## ADDENDUM THREE

Ivy Flats  
205 Rumely Street  
LaPorte, IN 46350

Commission No.: F22131

Addendum Date: 29 April 2024

**P104**

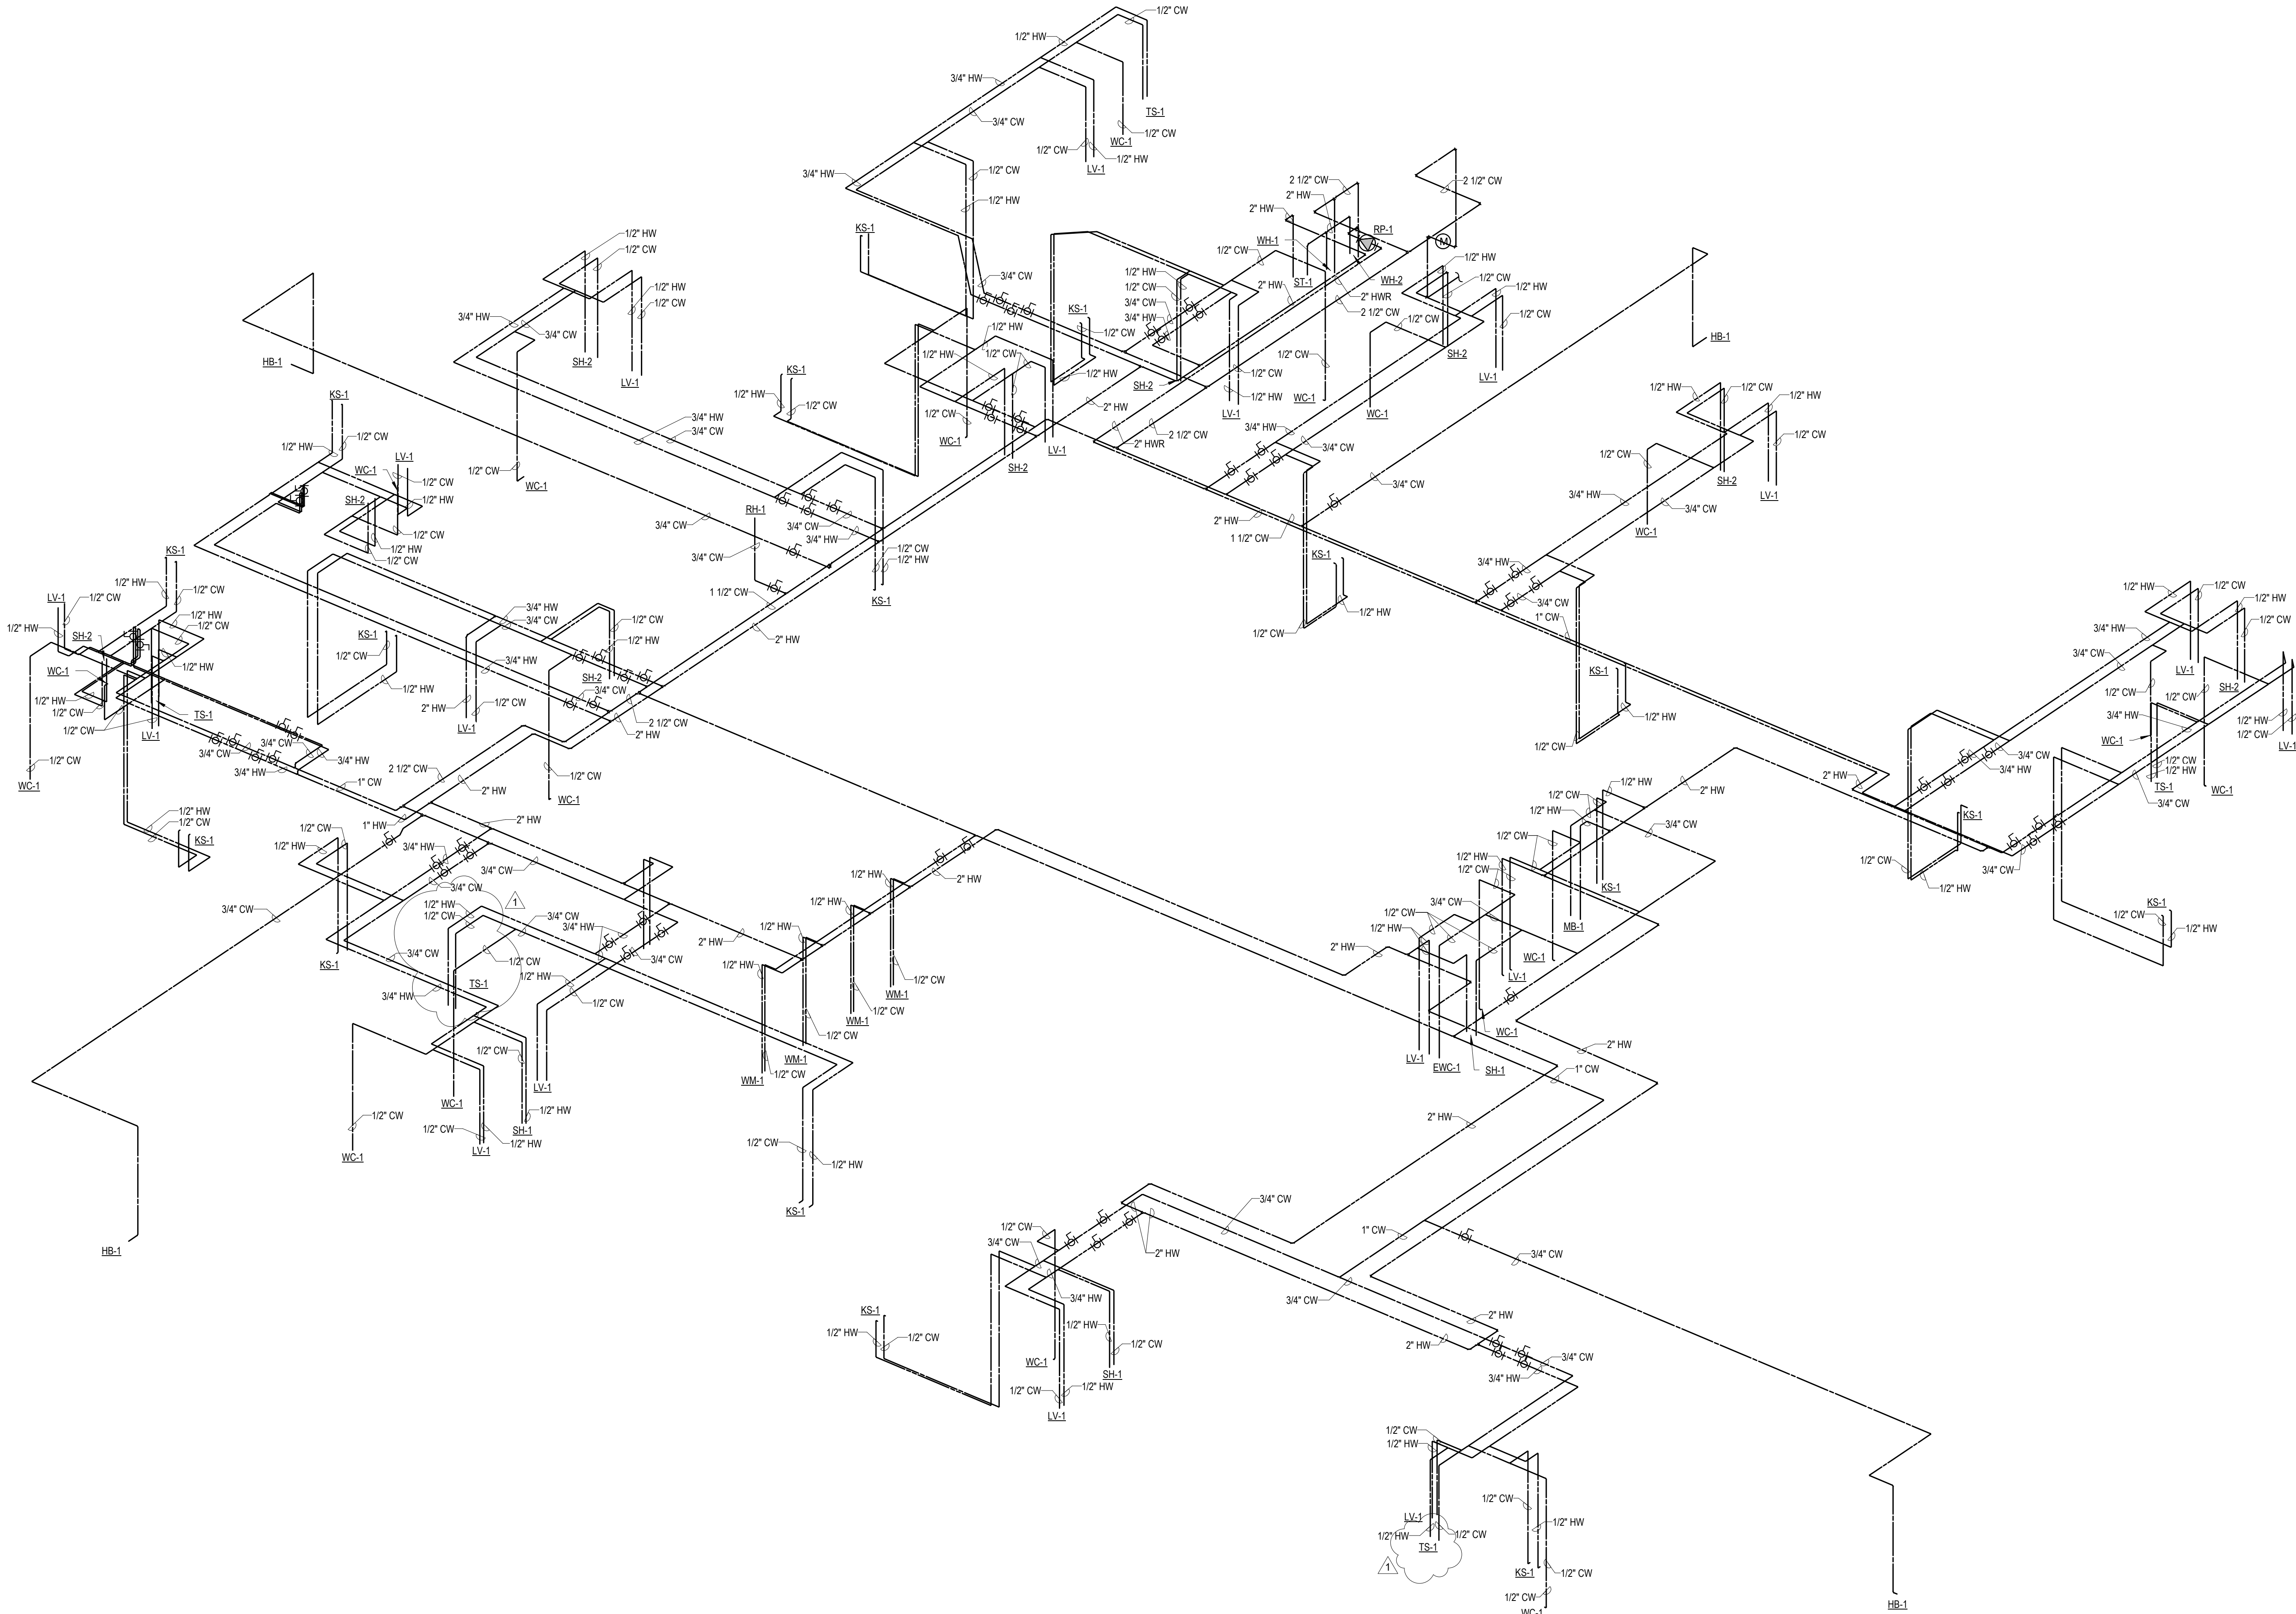
Could you please clarify if unit C gets a tub/shower unit or a roll-in shower? Page A111 shows it as a tub/shower unit and P104 shows it being an SH-1 (Roll-in shower).

**Answer:** (MR) Sheet P104 has been updated to display the correct condition.
